Product Change Notification

July 26, 2018

Bourns® Model PTVS10-0xxC-M Series High Current Power TVS Diodes *Change to Terminal Layout*

Existing Terminal Layout

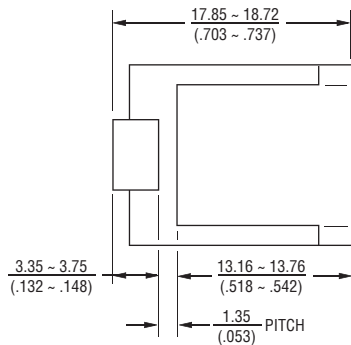
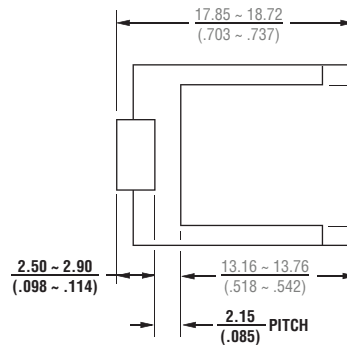
In the spirit of continuous improvement, Bourns is making a change to the pad layout for the Bourns® Model [PTVS10-0xxC-M](#) Series High Current Power TVS Diodes. The pitch between the two terminals is being increased from 1.35 mm to 2.15 mm.

The change to the terminal layout has no impact on the form, function, quality or reliability of the product. The only impact to “fit” is the change in terminal layout for increased pitch. The product marking and label will remain unchanged.
